Environmental Assessment Errata Sheet

Loop 375 (Transmountain Road) from I-10 to 0.479 mile East of the Tom Mays Unit of the Franklin Mountains State Park Entrance

CSJ 2552-01-033

August 9, 2011

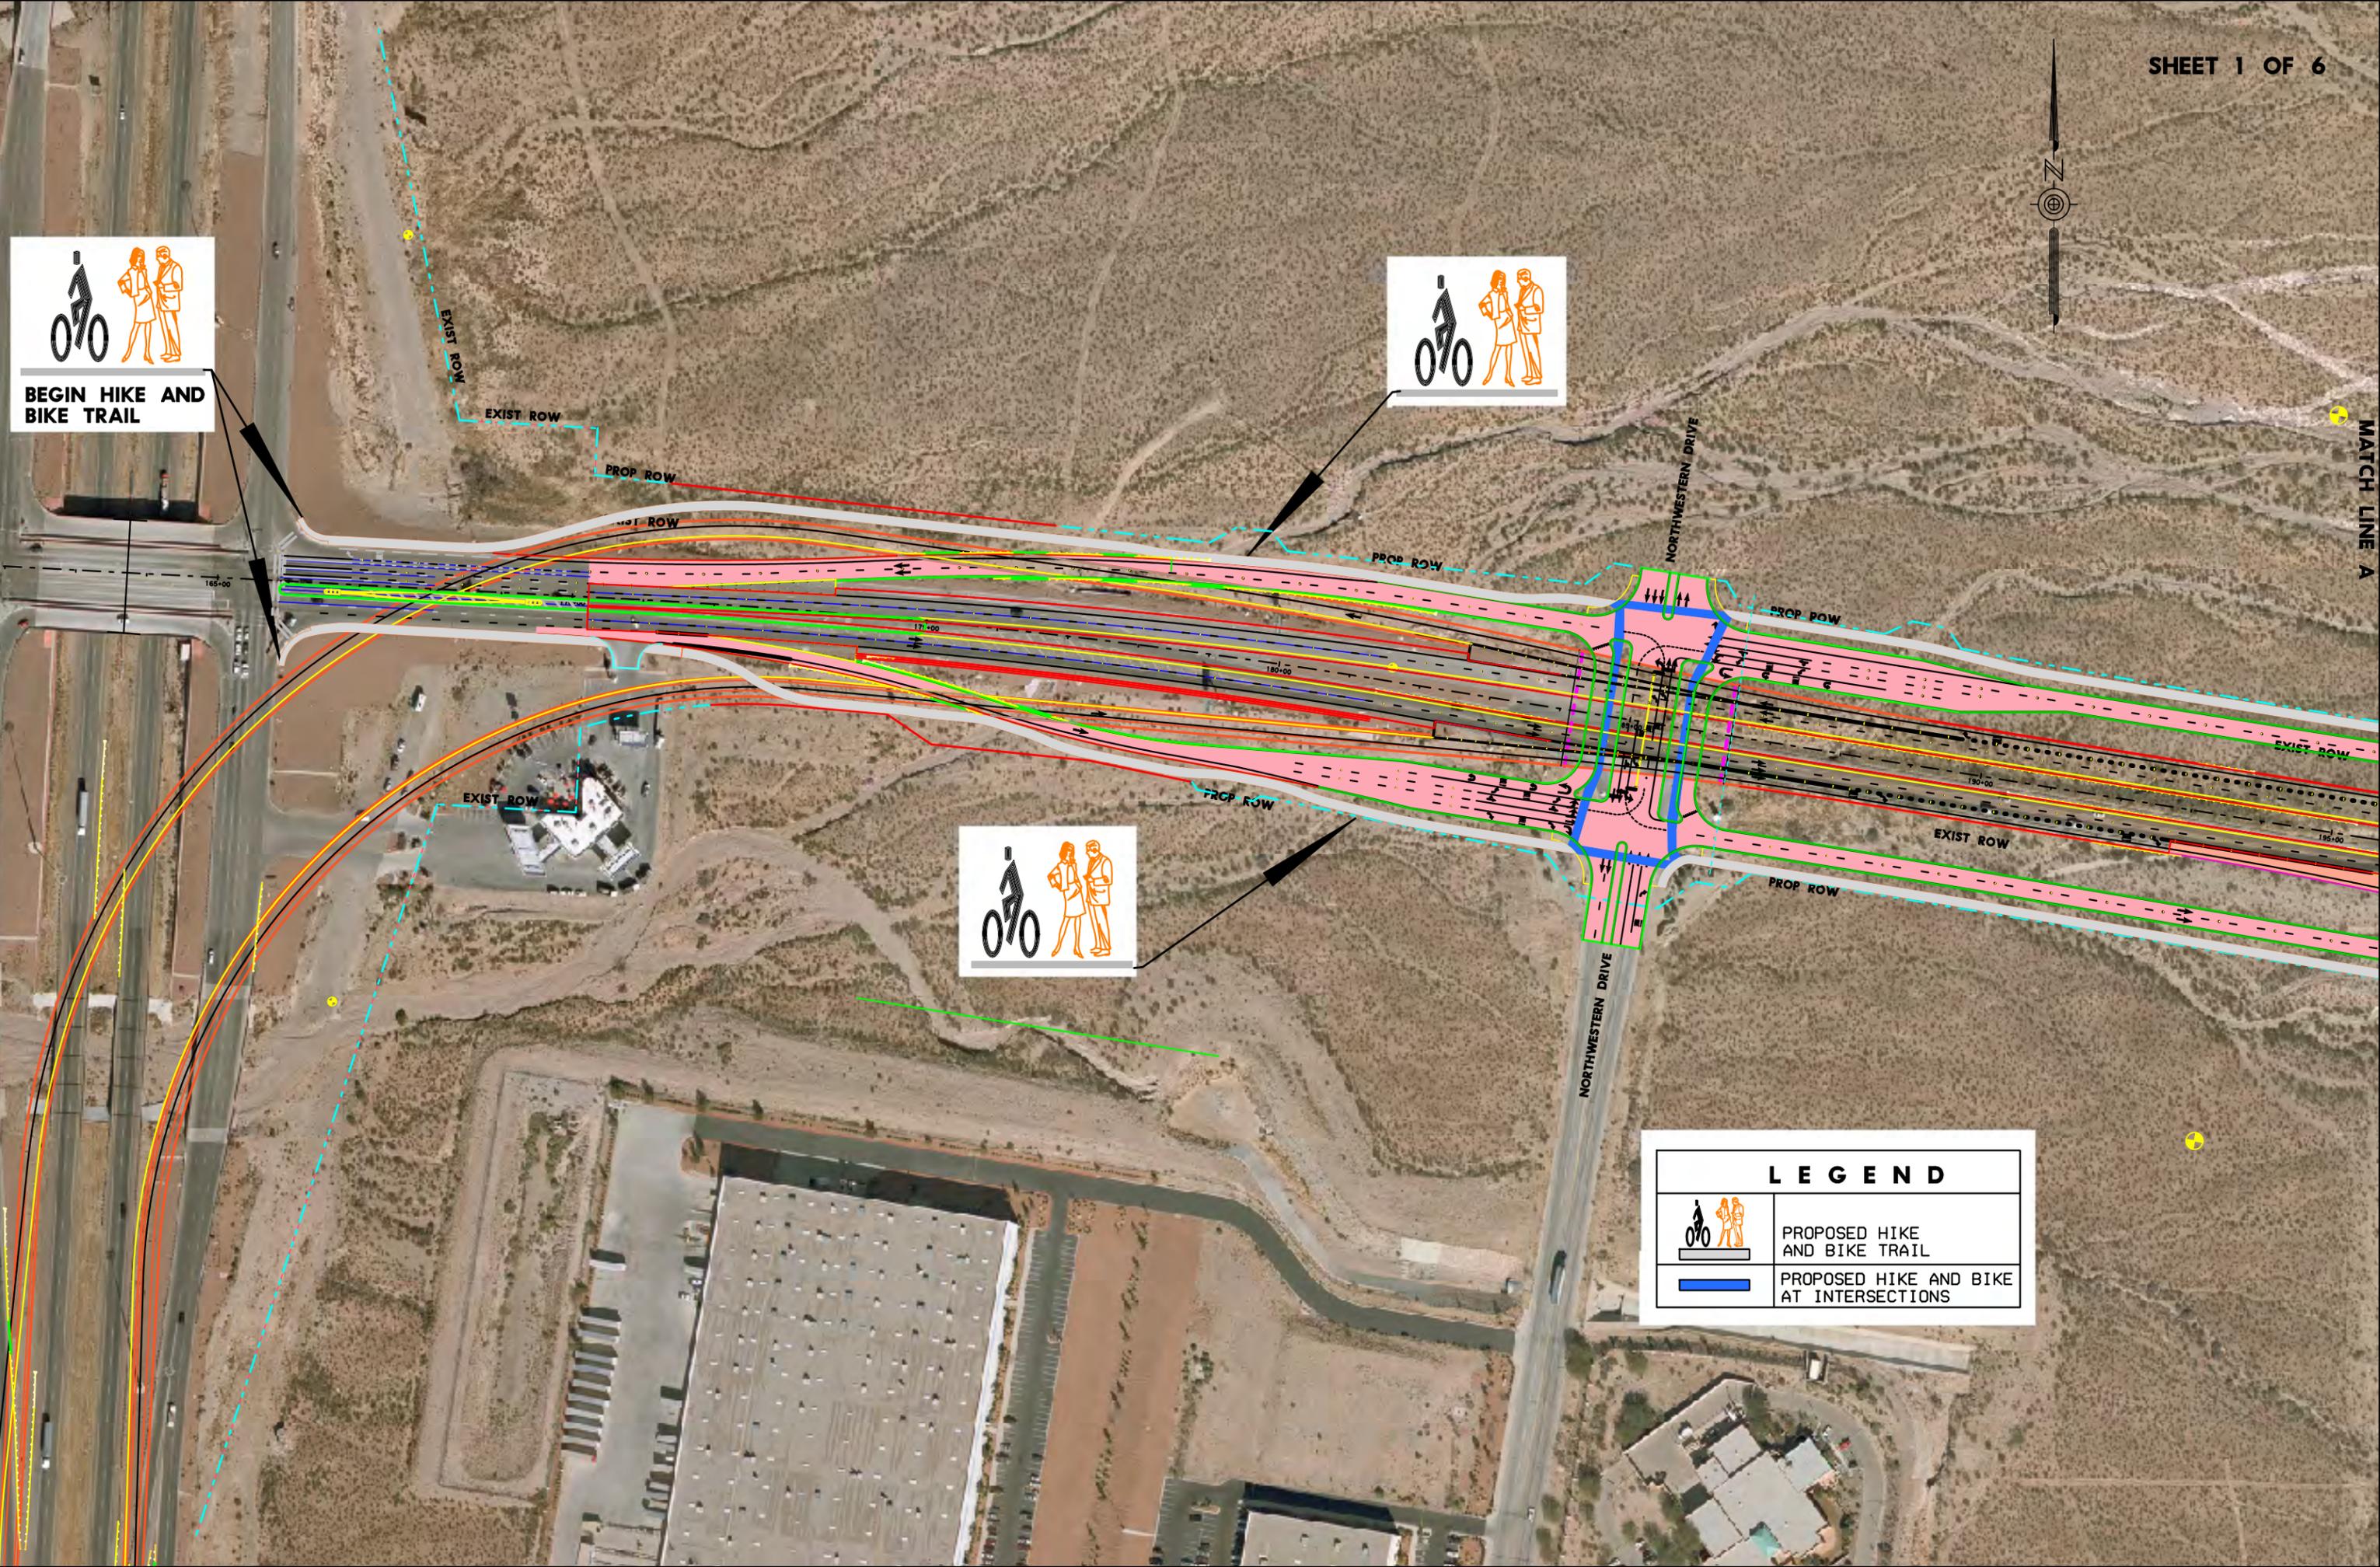
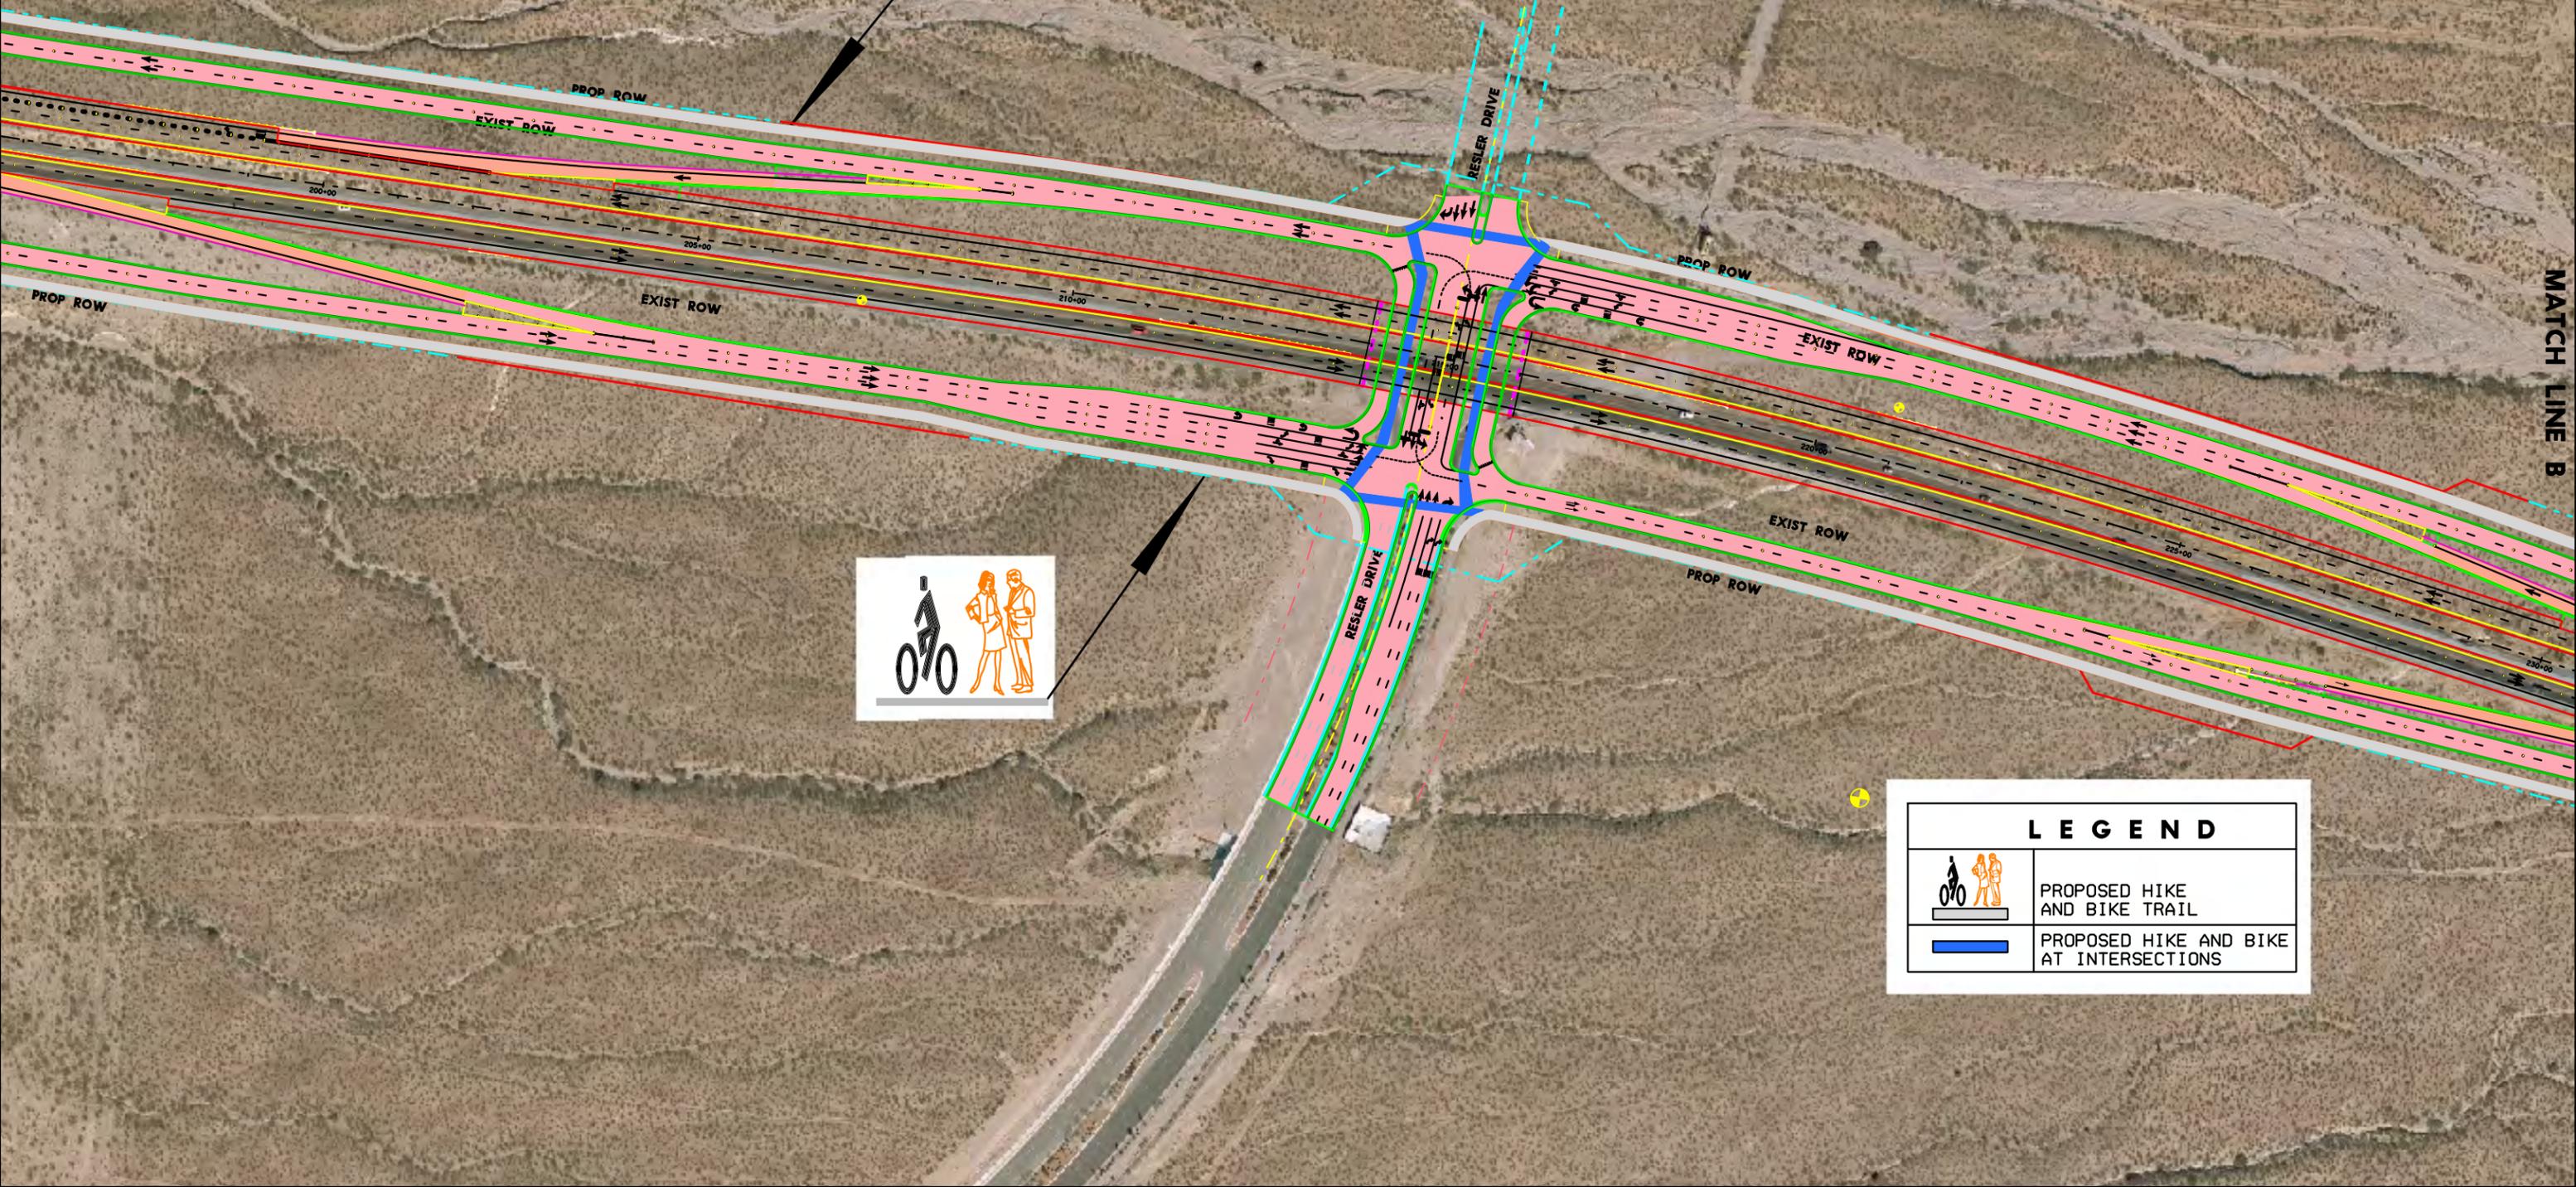
23. Page 119, Section 3.15: the following statement is added as an additional bullet regarding the proposed hike-and-bike trail:

***TPWD Comment 3:** The February 2011 EA (Page 25 and Figure 4.4) retains the south side hike and bike lane terminus at the frontage road. However, the February 2011 EA (Page 25) commits to encouraging foot and bicycle traffic to cross to the north side of Loop 375 at the Paseo Del Norte Road intersection to continue eastbound towards the Franklin Mountains State Park.*

“TxDOT will construct a hike-and-bike trail north of LP 375 inside existing highway right of way from the proposed Paseo Del Norte Drive and the FMSP driveway. This portion of the hike-and-bike trail would connect with the hike-and-bike trails proposed for construction between I 10 and the future Paseo Del Norte Drive. The hike-and-bike trails located between I-10 and the future Paseo Del Norte Drive would have the option to access the highway shoulders of LP 375 east of the future Paseo Del Norte Drive, or to use the proposed hike-and-bike trail along the northerly right of way line of LP 375 to access the driveway to the Tom Mays Unit. Pedestrian and bicycle traffic would be encouraged to cross LP 375 at the Paseo Del Norte Road intersection using sidewalks and five-foot-wide dedicated bicycle lane, and continue eastbound towards the FMSP Entrance on the north side of the road.”

bicycle lane, and continue eastbound towards the FMSP Entrance on the north side of the road. A diagram noting the hike-and-bike trail system planned for the proposed project is attached to this letter for reference.

TxDOT Response to Comment 3: TxDOT recognizes the comment from TPWD and has designed signing for the proposed project to encourage pedestrian and bicycle traffic that uses the southerly hike-and-bike trail to use the northerly hike-and-bike trail in order to access the driveway to the Tom Mays Unit. Bicycle traffic that wishes to proceed eastbound along Loop 375 will continue to have the option to use the eastbound shoulder of Loop 375 east of the future Paseo Del Norte Drive.
